2.0 PROJECT DESCRIPTION COMMENTS AND RESPONSES

STATELINE RETAIL CENTER

Figure 2-7: Key Map to Visual Assessment
 Stateline Retail Center
 Town of Southeast, Putnam County, New York
 Base Map: USGS Topographic Quad

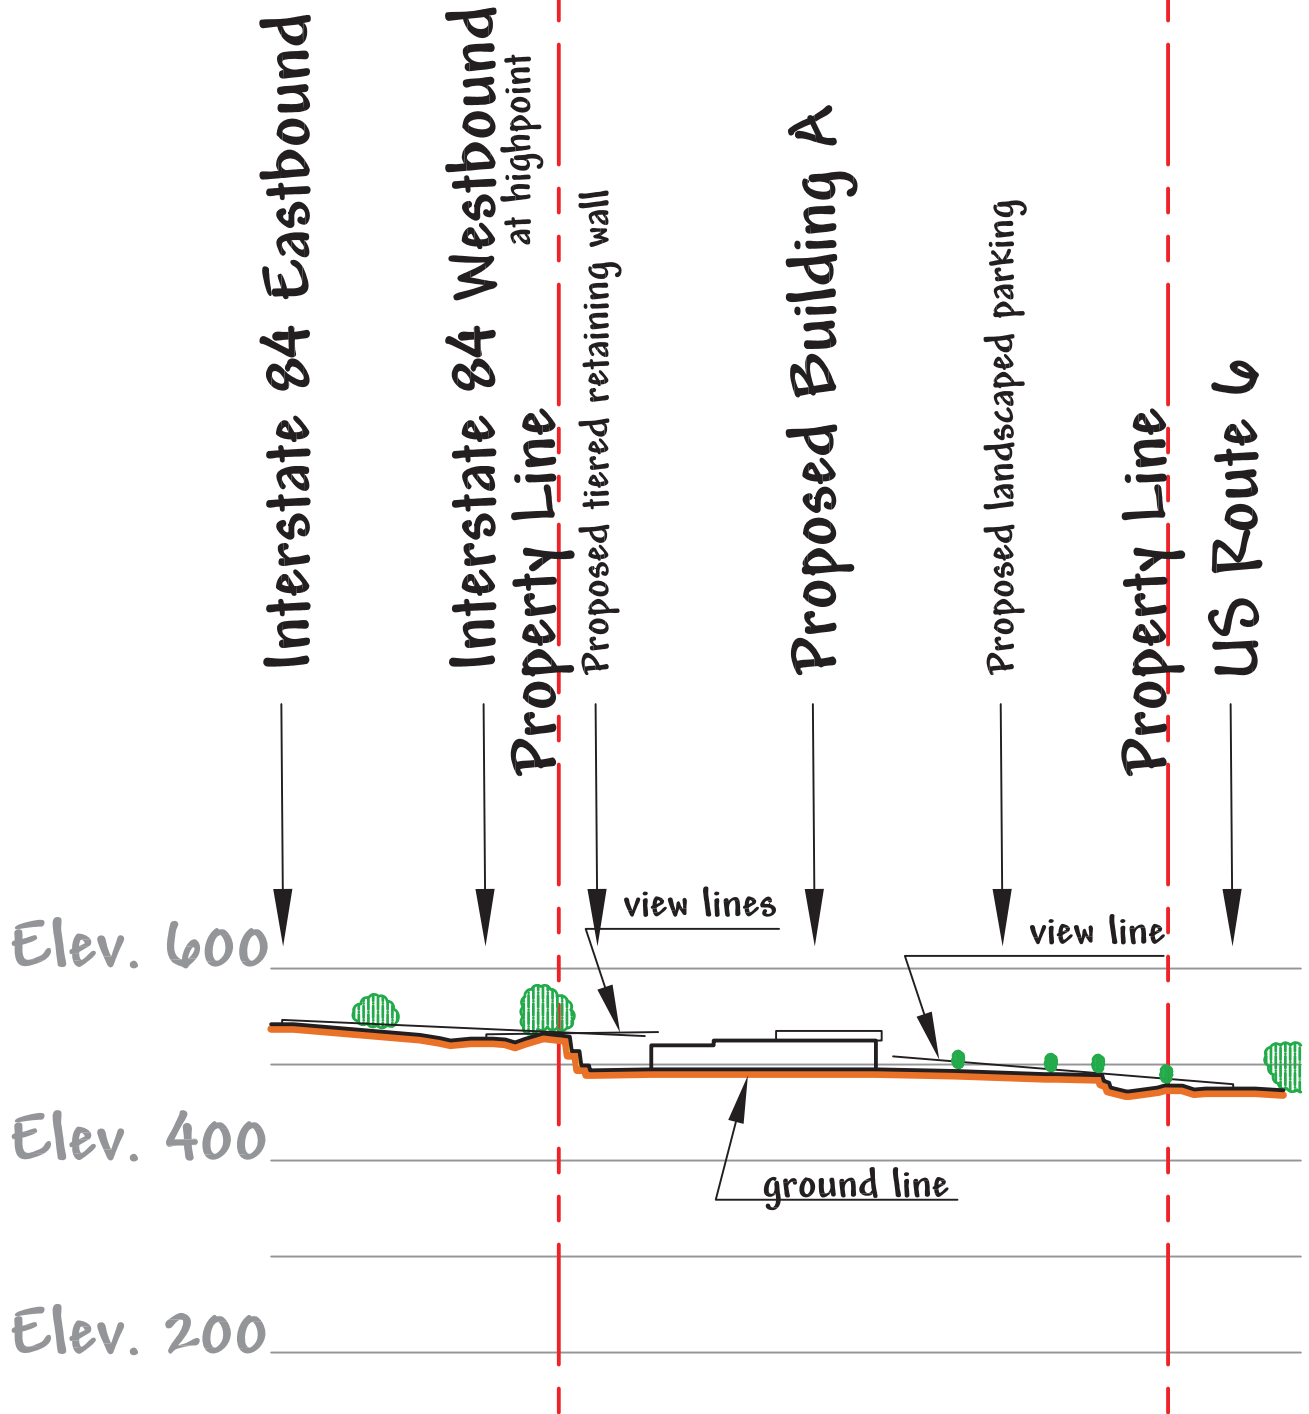
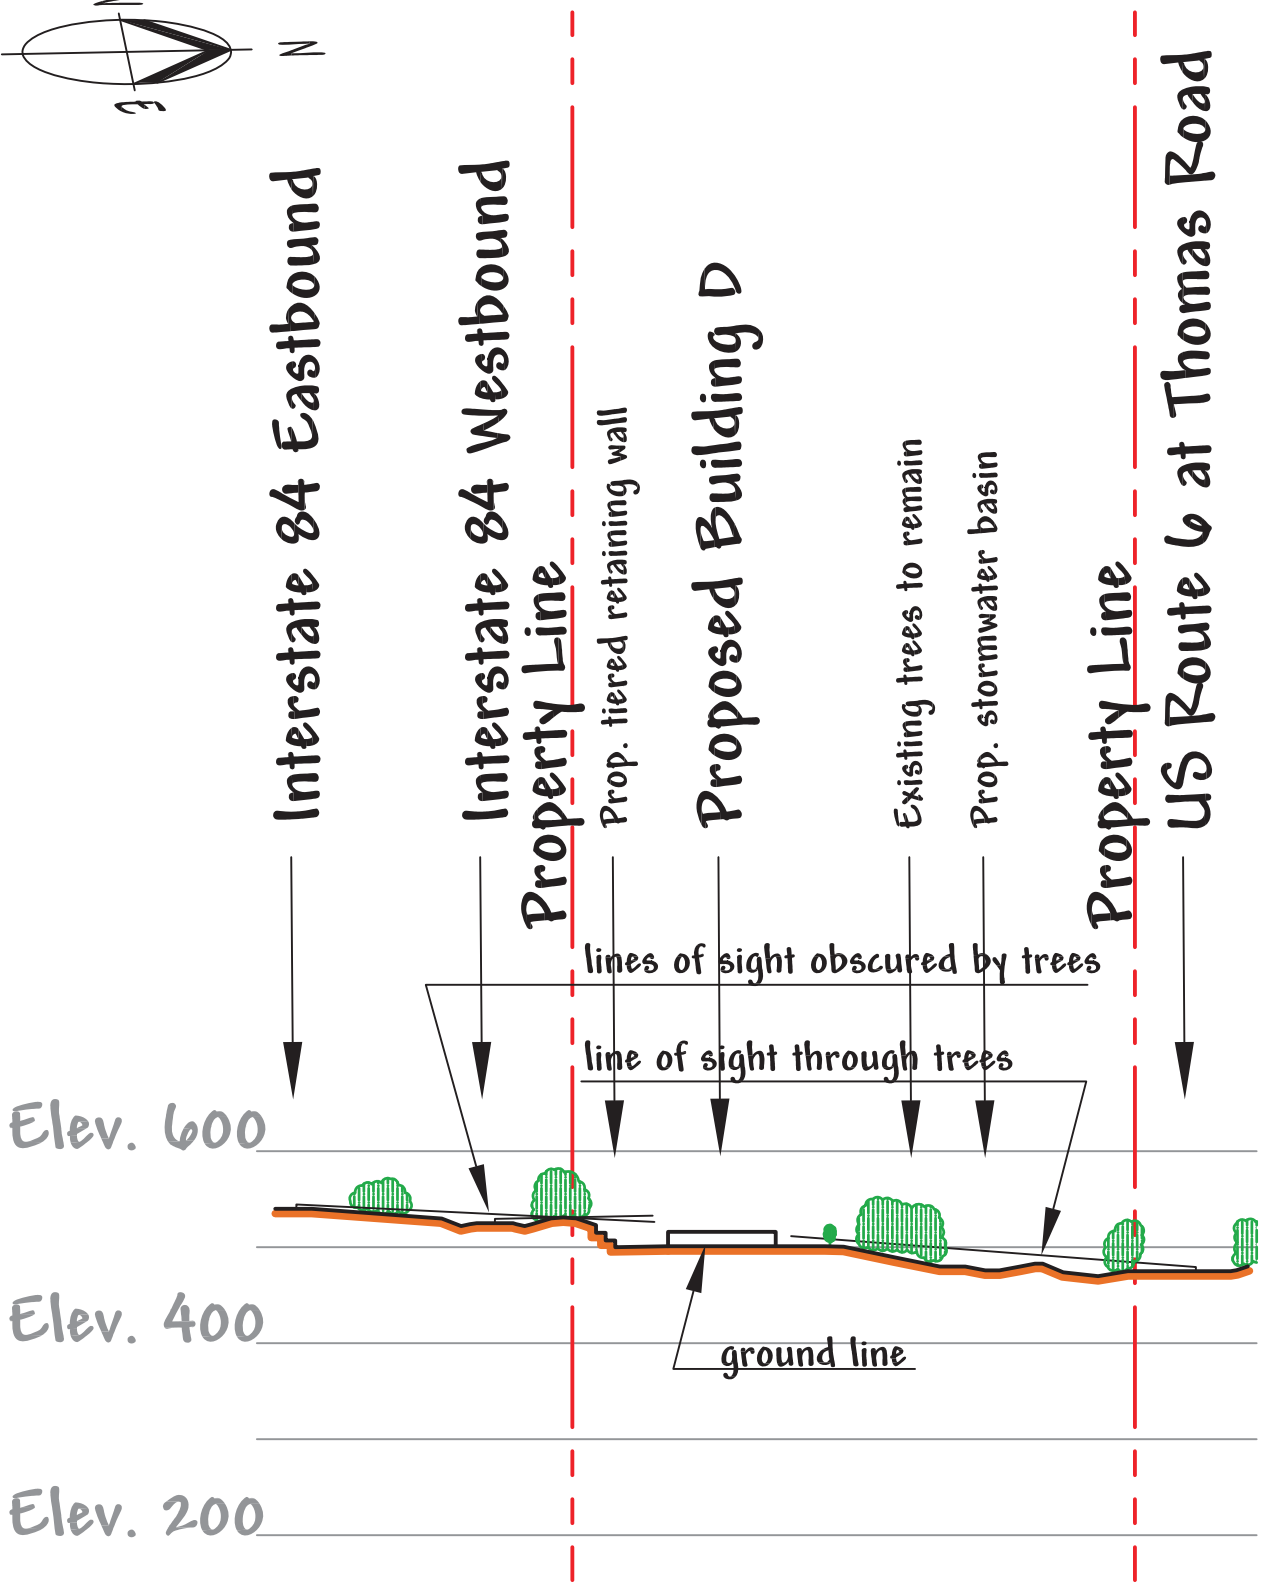
Comment 2.0-10 (Mr. Dan Armstrong, Public Hearing, July 14, 2008): My understanding is that the ordinance says that you must treat all facades with the same architectural treatment. So there has to be some kind of treatment of the facade that faces 84...you did show the side facade.

Refer to Figures 2-7, 2-8, 2-9, 2-10 and 2-11 (originally presented in the DEIS) and Figure 2-2 for a series of sight-line drawings into the project site from various vantage points along Interstate 84. The three dimensional animation contained in Appendix C and offered on the Town website provides views of the developed project from the perspective of vehicle occupants traveling both east and west on Interstate 84. Due to the limited visibility into the site from the highway, motorists will not see the rear of the proposed buildings. Nonetheless, while not as articulated as the front, the Applicant and the project architect have included architectural treatments including towers, columns, standing seam metal roofs and a variety of building materials and colors, for employees and delivery vehicle drivers who will travel to the rear of the buildings. Note, patron parking and traffic are not proposed for the rear of the building. Figures 2-3 and 2-6 depict views of the rear of these buildings.

Figure 2-14: Sidewalk Plan
Stateline Retail Center
Town of Southeast, Putnam County, New York
Source: DCAK-MSA Architecture
Drawing Date: 11/25/08
Scale: As shown

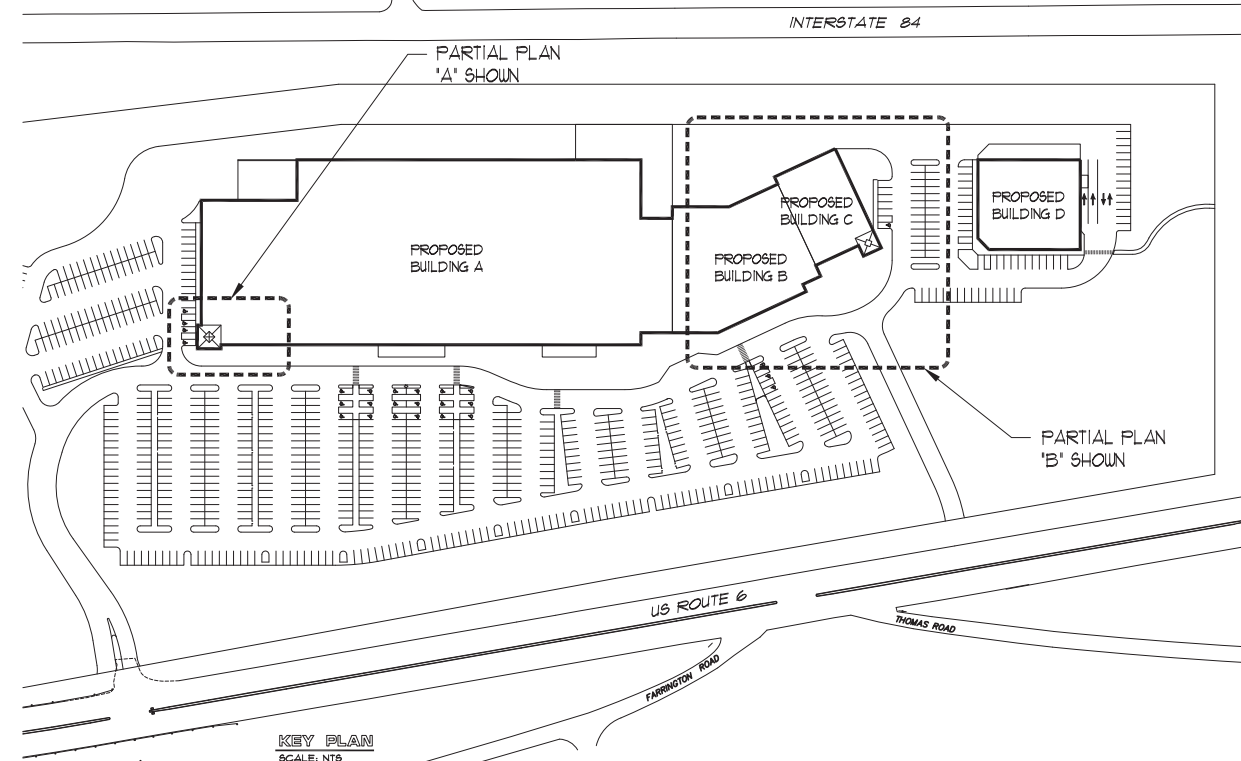
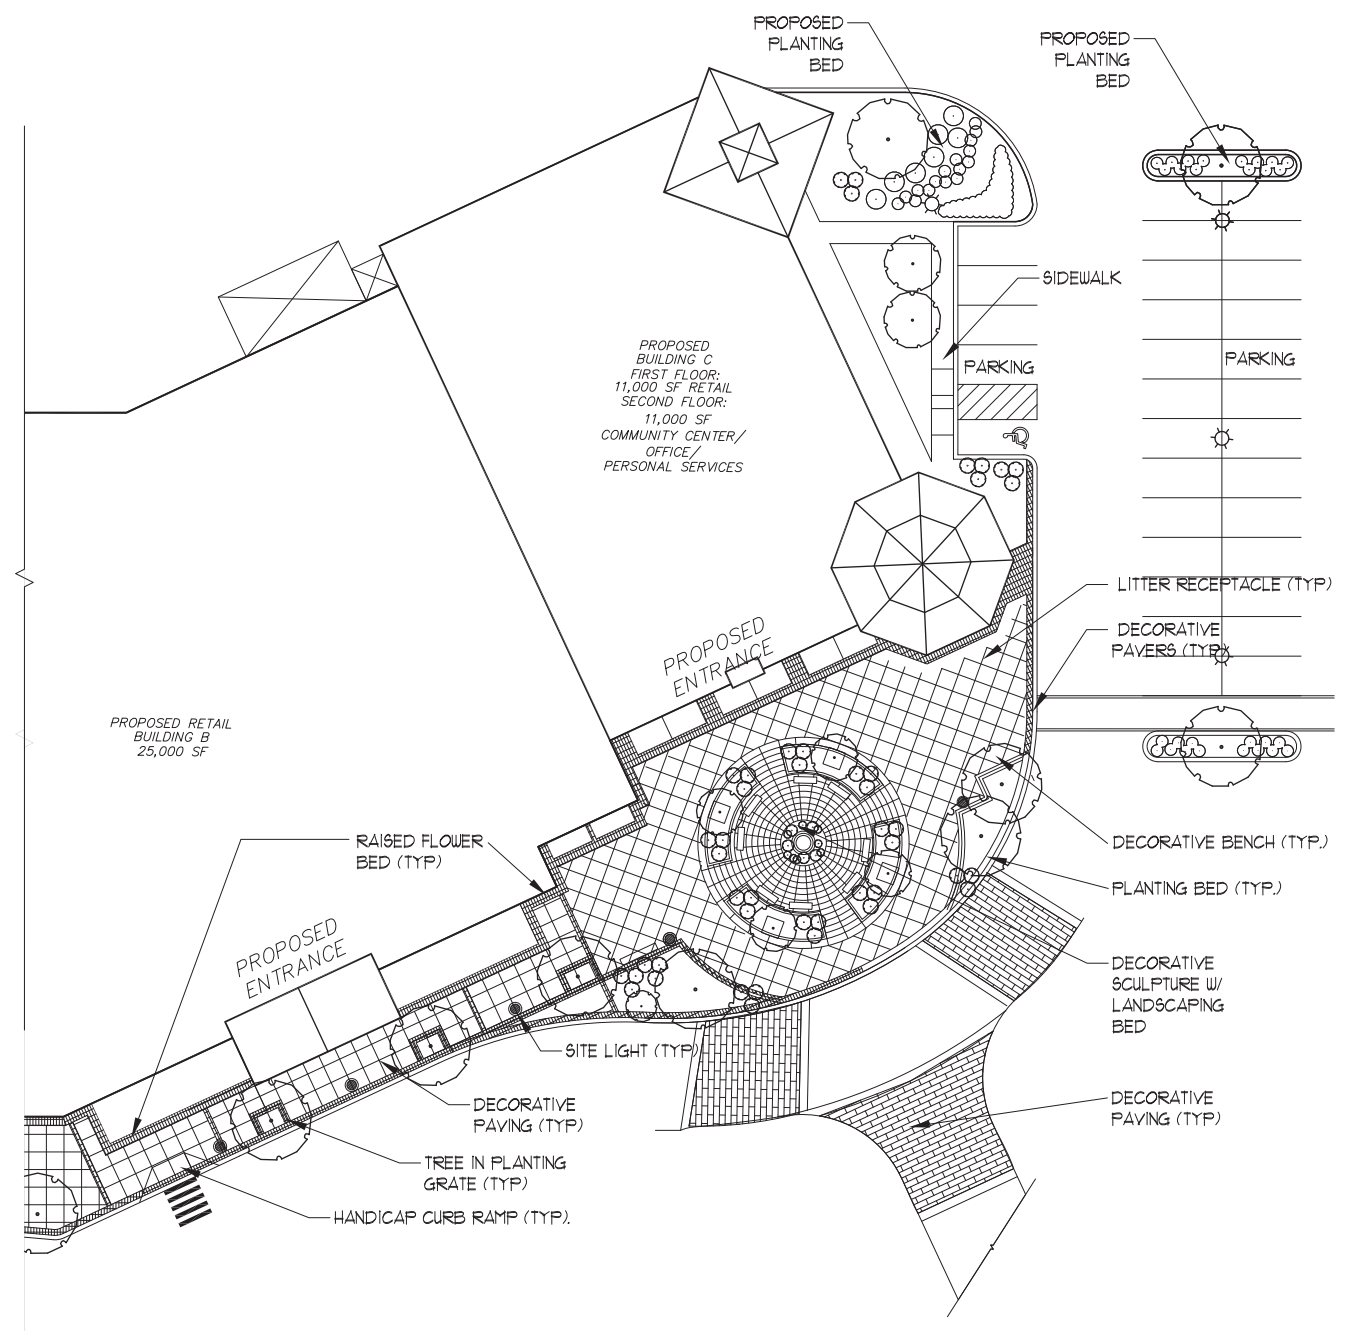
Comment 2.0-15 (Ms. Lynn Eckhart, Public Hearing, July 14, 2008): Also, it is said that there could be a fountain; there could be different paving. It would be nice to pin some of that down; a fountain sounds a lot more appealing, I'm sure to some of us, than different paving.

Response 2.0-15: *Landscaping and decorative paving will be incorporated into the proposed development along with other architectural and visual features. Refer to Figures 2-1 and 2-14 for examples of landscaping and paving, Figures 2-3, 2-4, 2-5 and 2-6 for architectural features as well as FEIS plan Drawing Nos. SP-2.1 and SP-2.2 and Appendix D herein.*
